## 148 Bay Avenue Project Description - UPDATED for ZBA

### NOTICE OF DISAPPROVAL

PLEASE TAKE NOTICE that your application dated October 15, 2021 - to make alterations to a 3-story building at 148 Bay Avenue - is returned herewith and disapproved on the following grounds:

The premise to which this application applies to is located at:  
148 Bay Avenue, Greenport, New York 11944.

1 PROPOSED SITE PLAN  
3/16" = 1'-0"

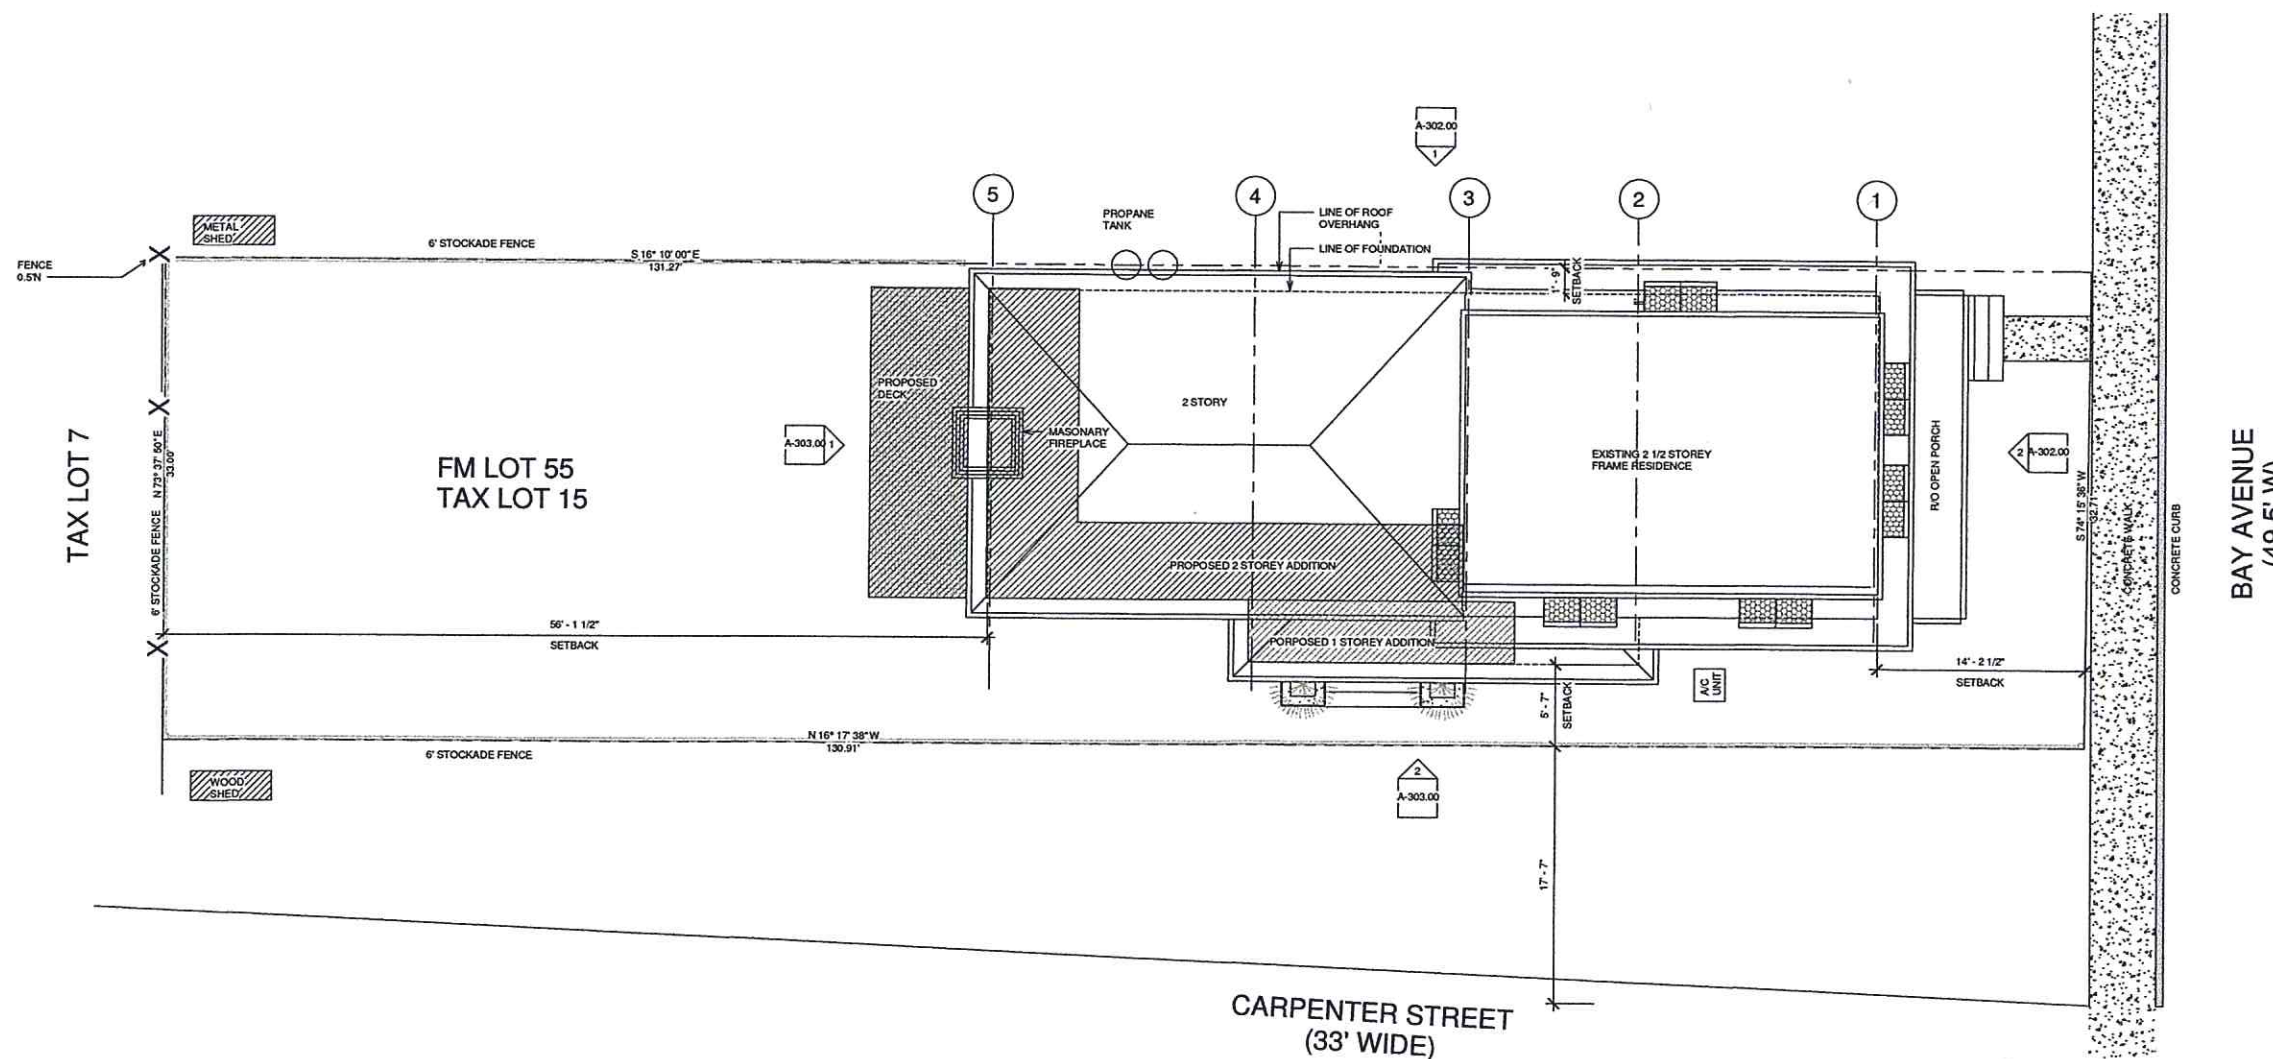
The specifications show the proposed lot coverage is 1,540 SF (35.7%). The allowable lot coverage is 1,292 SF (30%). This would require an area variance of 248 SF (5.7%) lot coverage increase.

The plans show the front yard setback of 14.7 feet. This would require an area variance of 15.3 feet.

The plans show a West yard setback of 5.7 feet. This would require an area variance of 4.3 feet.

The plans show an East side yard setback of 1.5 feet. This would require an area variance of 8.5 feet.

The calculated combined side yard set back is 13.1 feet. (0.4 x 32.71) The plans show proposed combined setback of 7.2 feet. This would require an area variance of 5.8 feet.

The plans show no off-street parking to be provided. This would require a variance for 2 off street parking
